ADDENDUM NO. 2

Project: Hanover Road Sewer Meters
AWCK Project No. 22009

Addendum Date: March 16th, 2023

SANITARY SEWER
PLAN & PROFILE

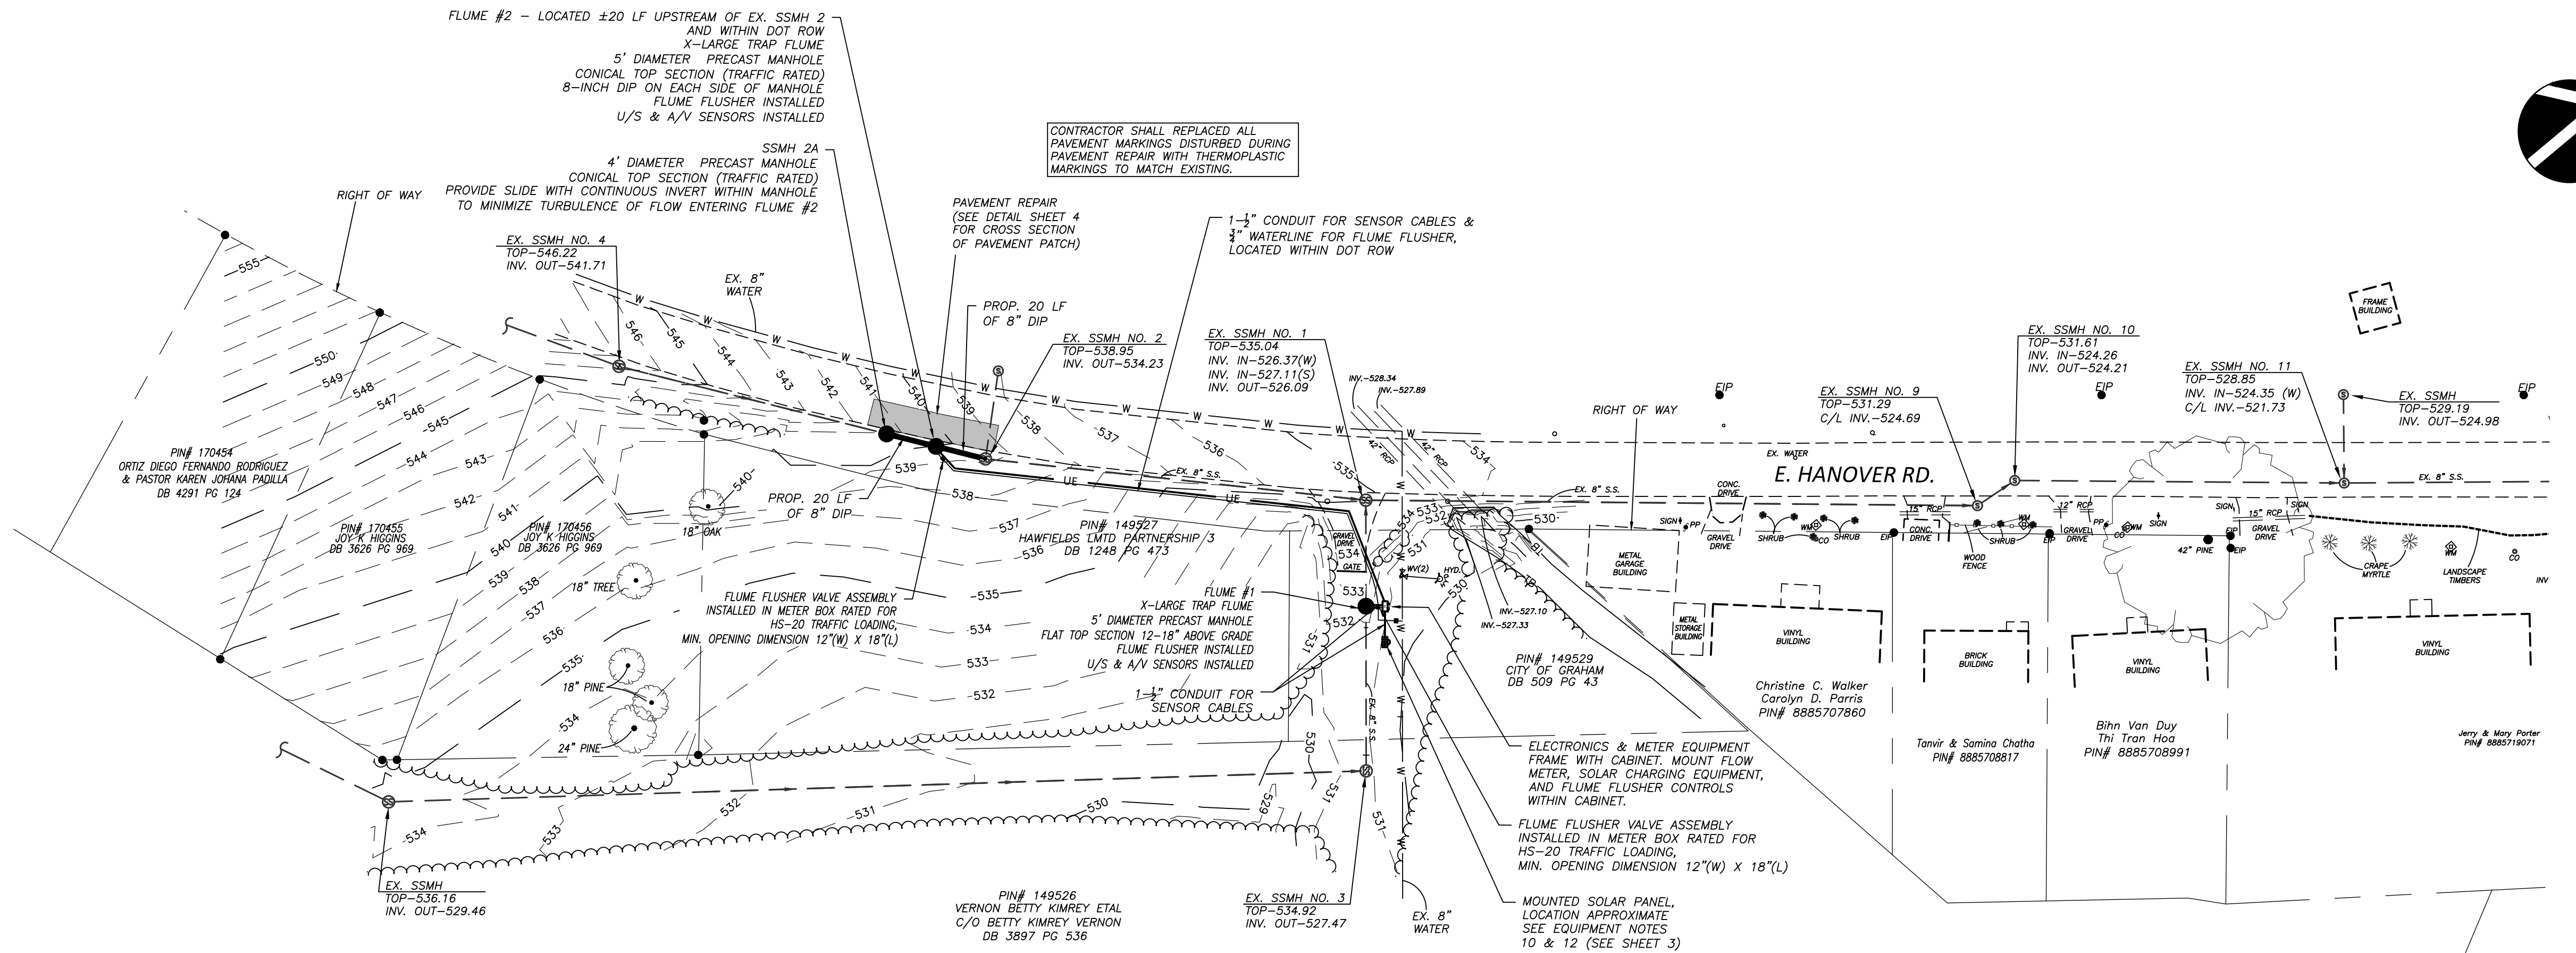
1. Plan Sheet 2 was revised to include an additional manhole (SSMH-2A) and ten additional feet of proposed 8" ductile iron sewer main. The slope of the proposed sewer main was reduced to 1.50% to increase meter accuracy. A slide will be installed within SSMH-2A to make up the elevation difference caused by the slope reduction. The limits of the pavement repair have been adjusted to accommodate the additional pipe length and manhole SSMH-2A. General notes on Plan Sheet 2 have been revised to accommodate the addition of SSMH-2A. Costs associated with these revisions shall be included within the lump sum bid item for Flume #2 (Bid item #4).
2. Note 14 was added to Plan Sheet 3 to provide additional information regarding the solar equipment to be provided by the contractor. Costs associated with this solar equipment shall be included within the lump sum bid item for Flume #1 (Bid item #3).
